MANPRINT ASSESSMENT OF THE
HIGH MOBILITY MULTIPURPOSE WHEELED VEHICLE
HEAVY VARIANT (HMMWV-HV)
(Contract MDA903-83-C-0033)

March 1988

MANPRINT ASSESSMENT:

HIGH MOBILITY MULTIPURPOSE WHEELED VEHICLE HEAVY VARIANT (HMMWV-HV)

Figure 3.2.4. Sharp and abrading surfaces.

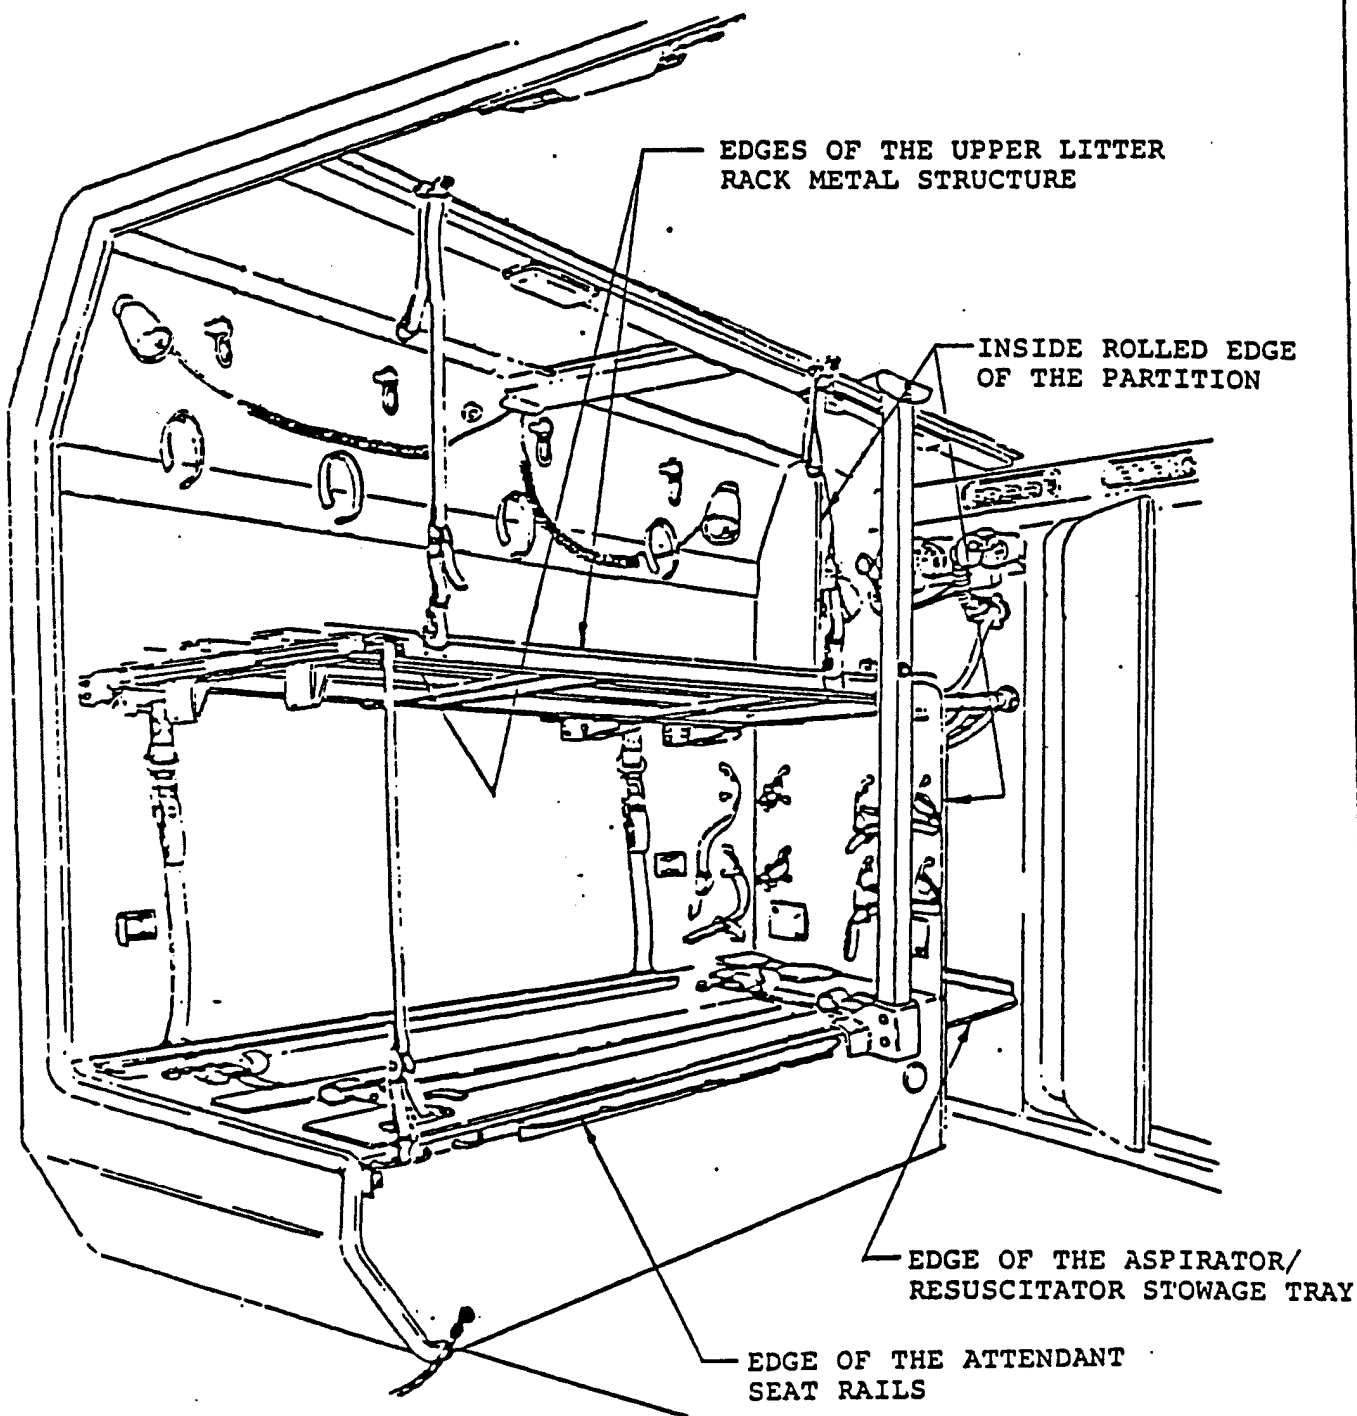
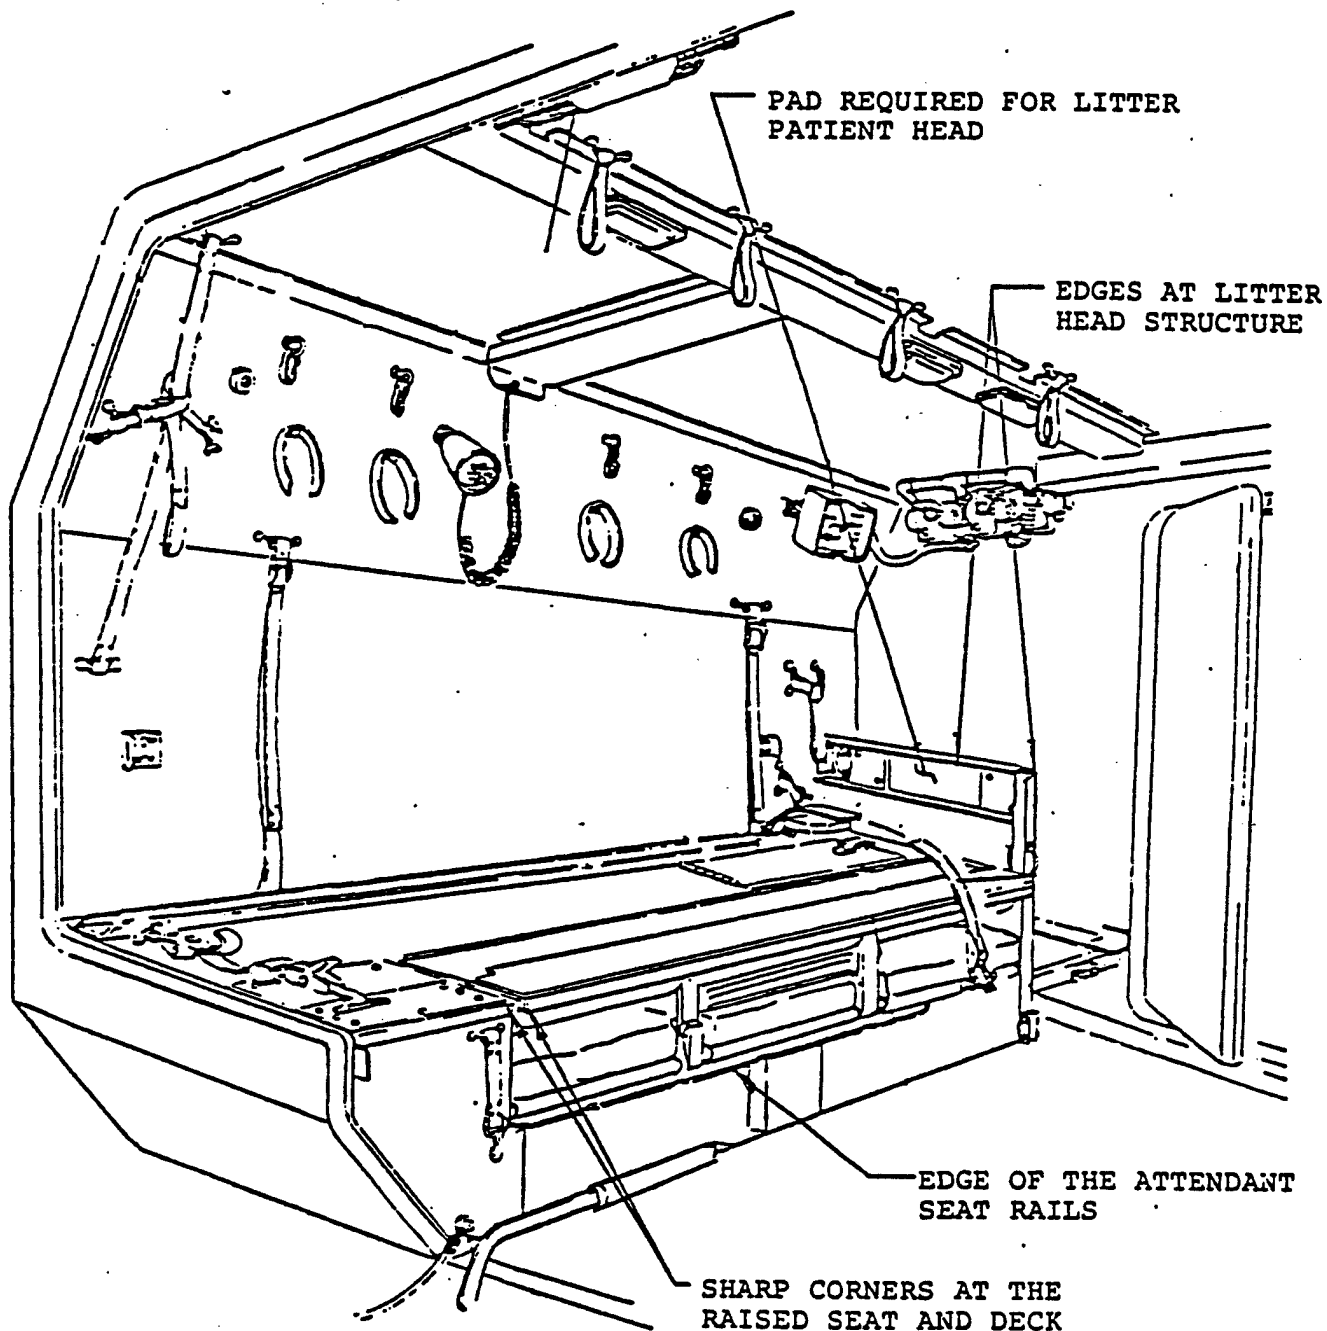
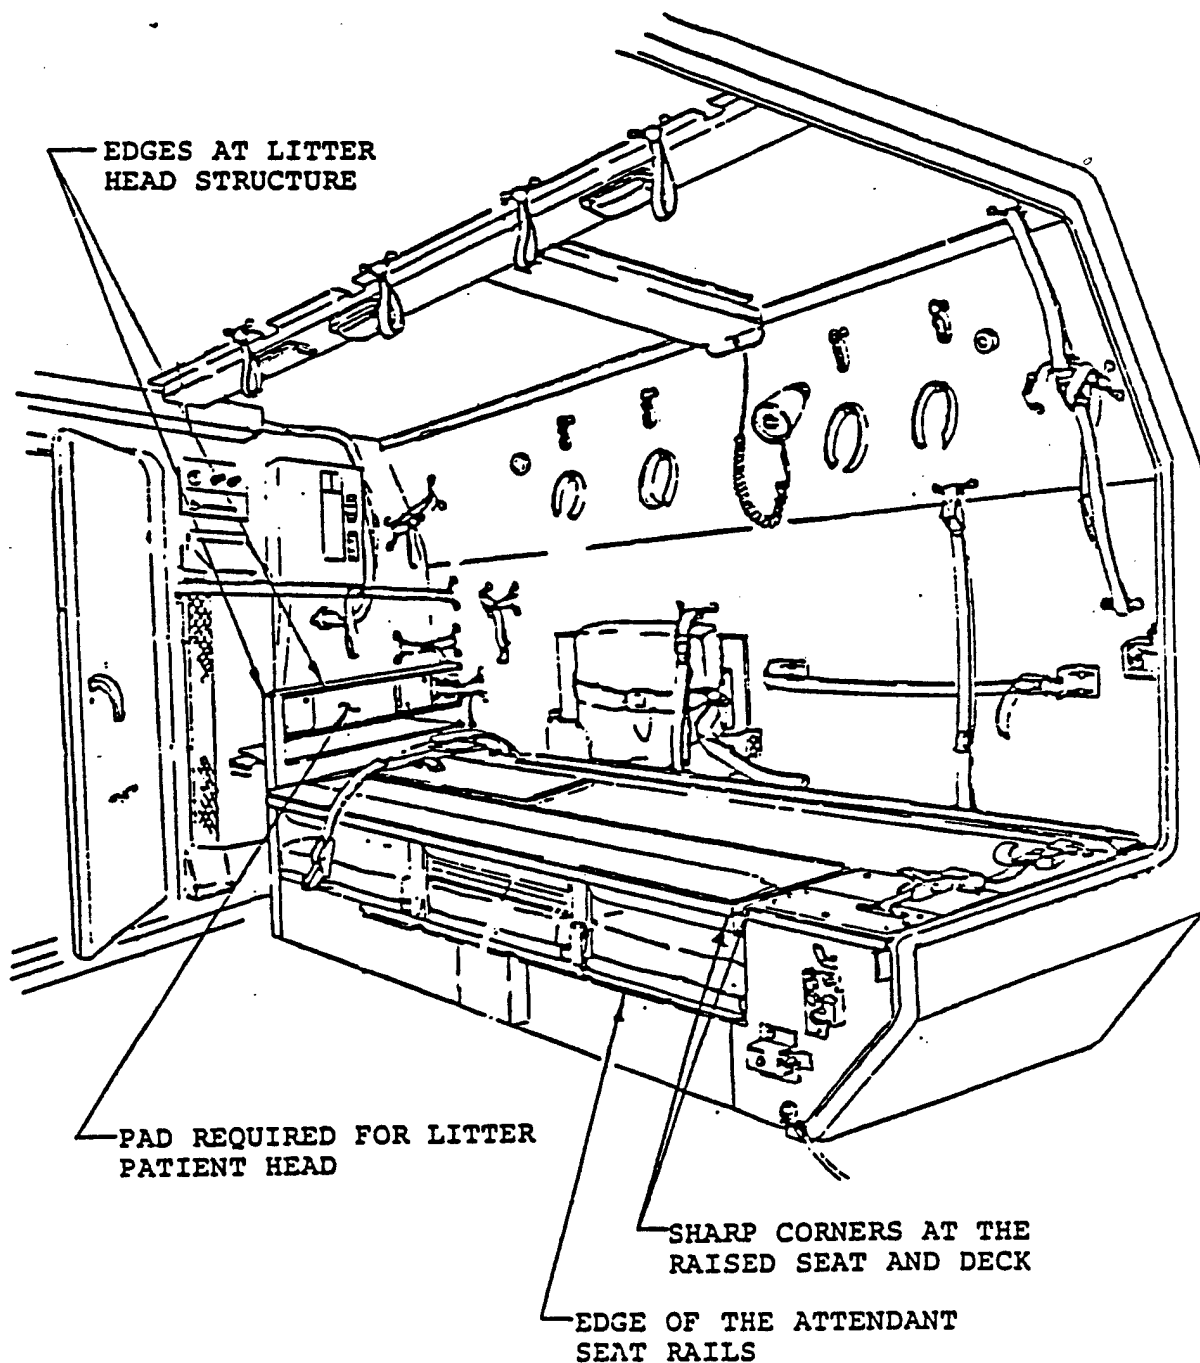
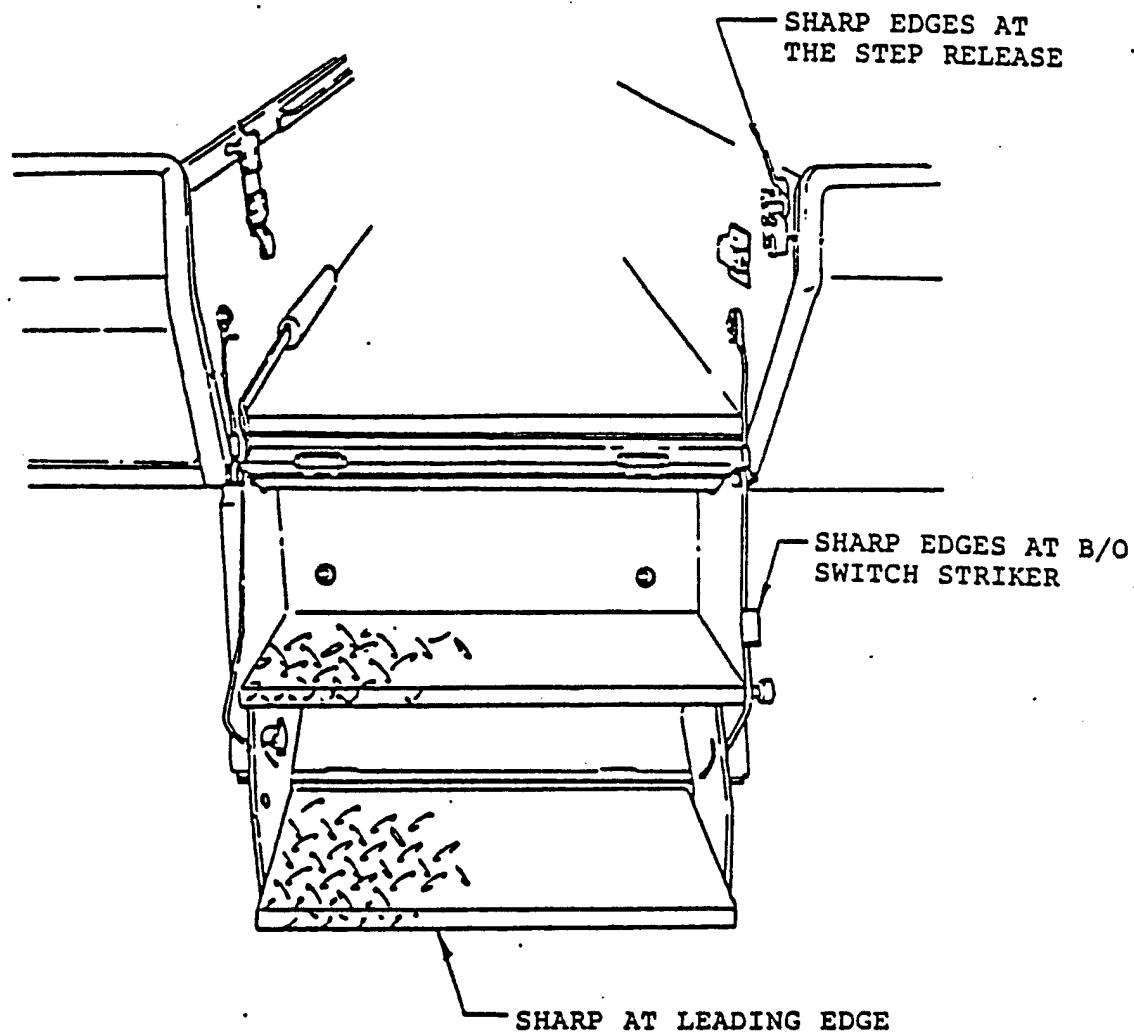
- 1) Litter ramp guide rails.
- 2) Edge located at attendant seat for retractable steps (see Figure 3.2.4).
- 3) Edges of attendant seat rails.
- 4) Edges of stowage brackets for aidman's seat.
- 5) Edges on step release lever.
- 6) Lower front corner of drivers and passengers door window frame.

Manufacturing processes that leave an unfinished edge and corners of equipment where projections are not padded or broken.

Sharp or abrupt edges and insufficient padding may result in injuries such as lacerations or contusions to operators and passengers. Insufficient padding leads to operator fatigue and reduced operator performance.

Roll all sheet steel edges. Radius or break all appropriate sharp corners. Add padding to surfaces as described.

Figure 3.2.5. Aidman's sliding seat.

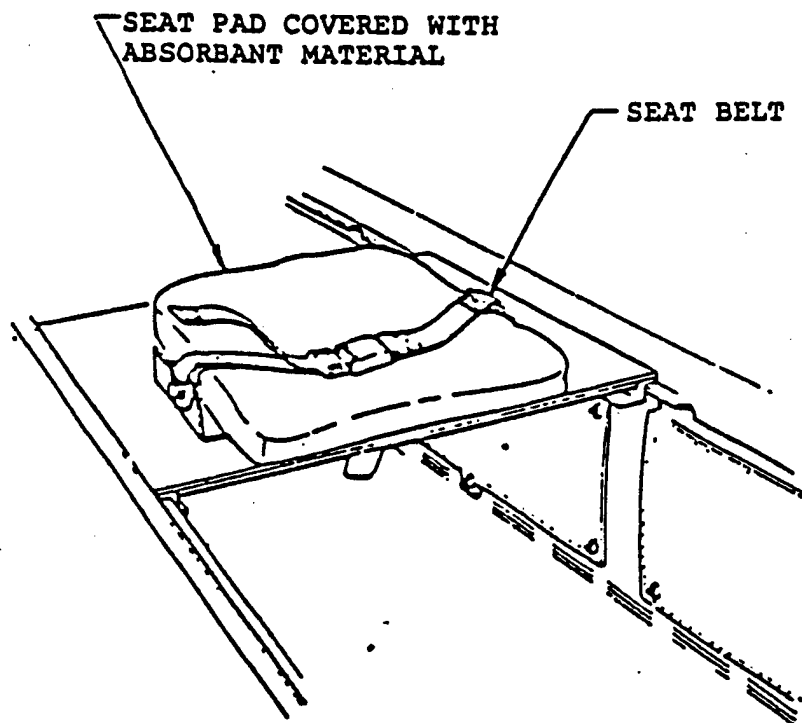
- a. The attendant seat cannot be locked into a position on its slide track so that the attendant can straddle the seat and work at a patient's head.
- b. Attendants are also pitched backward and out of the attendant's seat.
- c. Seat is covered with an absorbent material (see Figure 3.2.5).
- d. Aidmen cannot access the upper litter patient in the maxi-ambulance while secured to the aidman's seat.

a. Add additional detents into the seat slide track (especially one extra set of detents located directly between the two forward detent sets).

b. Incorporate a folding short lumbar support into the attendant's seat. The back of this folding support, when folded down, could be padded to allow the attendant to also straddle the seat. The folding back could be spring-loaded so the back would fold down when not in use to facilitate stepping over it.

c. Cover the seat with a heavy non-permeable vinyl covering.

Figure 3.2.6. Door latch handles.

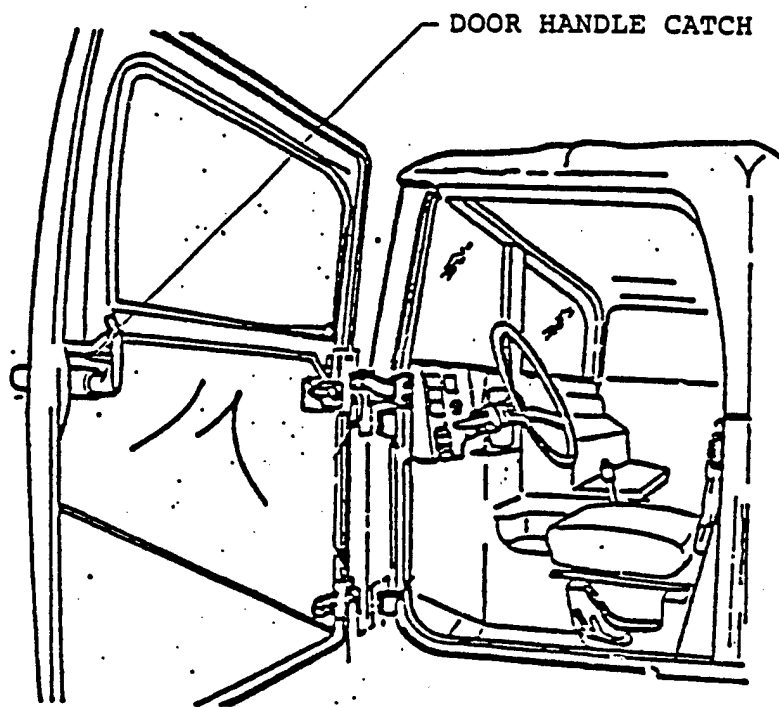
c. Door latch handles are prone to unlatching and are shown in Figure 3.2.6.

The poorly tensioned curtain allows the curtain to hit the crewmen in the back of their heads. Poor seals allow dust, cold drafts, and water to enter the crew cab. Doors have inadvertently opened during cross-country travel creating a distraction for the operator resulting in reduced vehicle control. The plastic windows defeat use of the side mirrors and reduce rearward vision.

Figure 3.2.7. Shelter carrier tailgate tripping hazards.

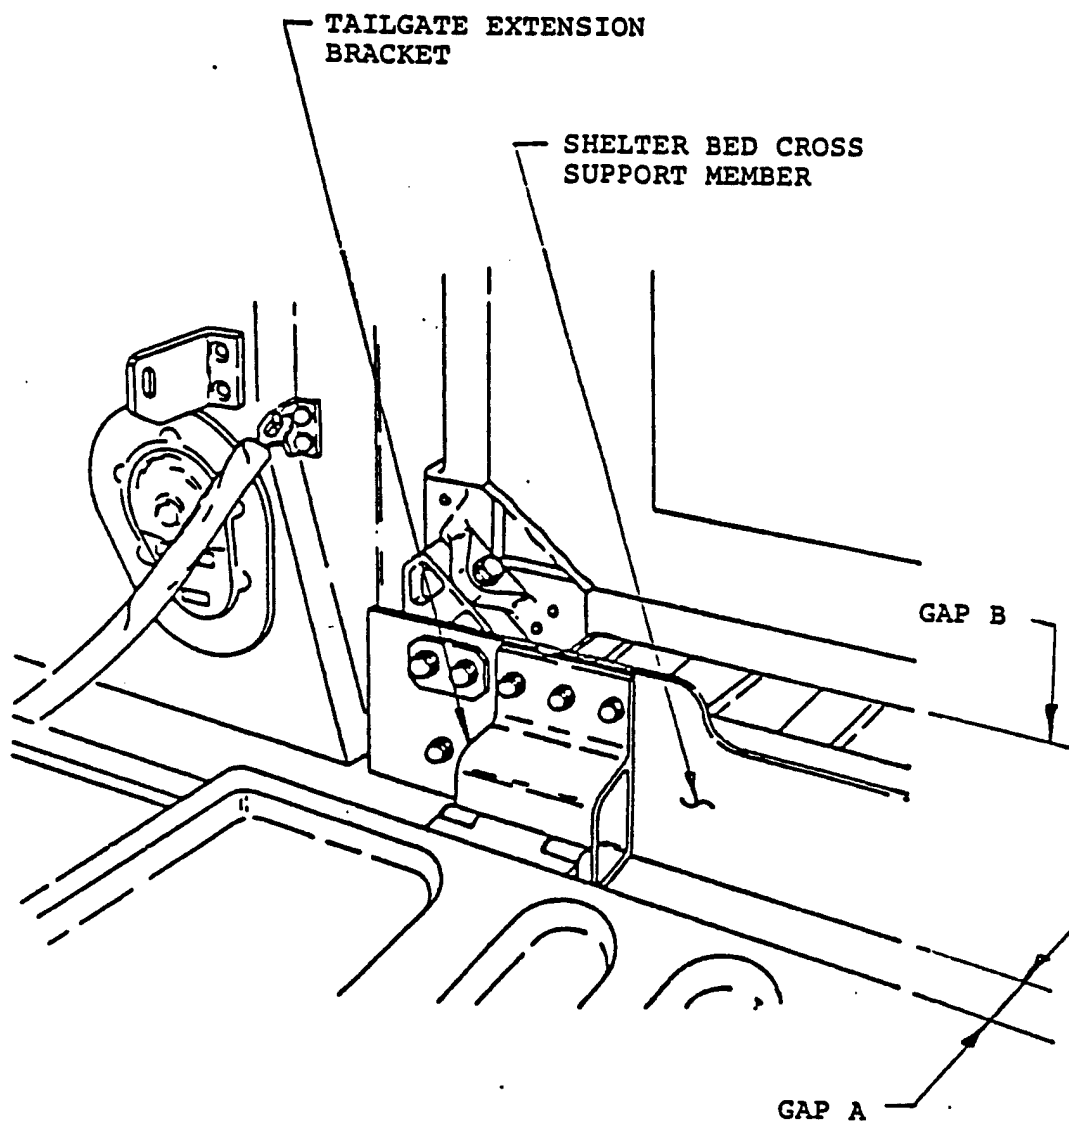
A tripping hazard exists for HMMWV-HV shelter carrier crewmen while entering or exiting the communications (S-250) shelter. There are two hazard locations shown in Figure 3.2.7:

a. The tailgate gap is large enough that a soldier's boot could lodge in the opening. A soldier when exiting the shelter and with his boot pinned in the gap could fall from the tailgate to the ground. Severe injury may occur to the soldier's pinned foot during such a fall.

b. A soldier's boot can become lodged between the unlifted shelter and vehicle bed. This may occur while a soldier is entering the shelter causing him to trip resulting in injury.

Add a horizontal plate attached to the shelter bed cross support member to fill the gap between the cross support member and the tailgate. This plate would be fitted to the cross support member.

Figure 3.3.1. Driver's seat adjustment slot.

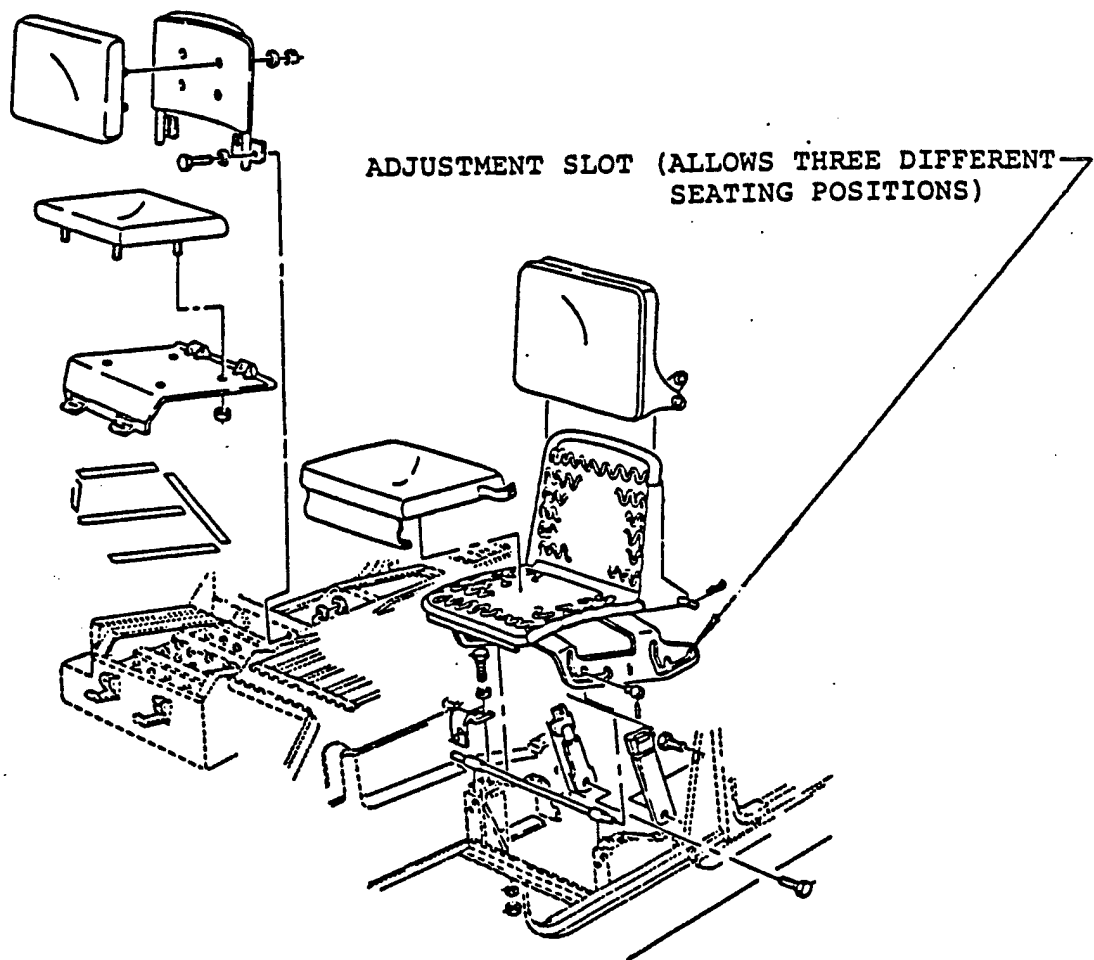
a. The width of the HMMWV and non-sloping hood reduce the driver's visibility to see critical frontal areas of the vehicle. The lack of driver's seat adjustment locations contribute to this problem and also leave many drivers with insufficient leg room. The three available seat adjustment positions are shown in Figure 3.3.1. Interviews with drivers have provided the following:

- a. Poor visibility of critical frontal areas:
 - 1) Low and close to vehicle directly in front.
 - 2) Right front quarter area.
- b. Operators' legs cramped into dash:
 - 1) Knees hit throttle control.
- c. Operators increase height by adding or packing gear below driver's seat pad:
 - 1) Improper use of equipment leads to unstable seating position.
 - 2) Reduces the effectiveness of the seat belt.

Redesign driver's seat to either:
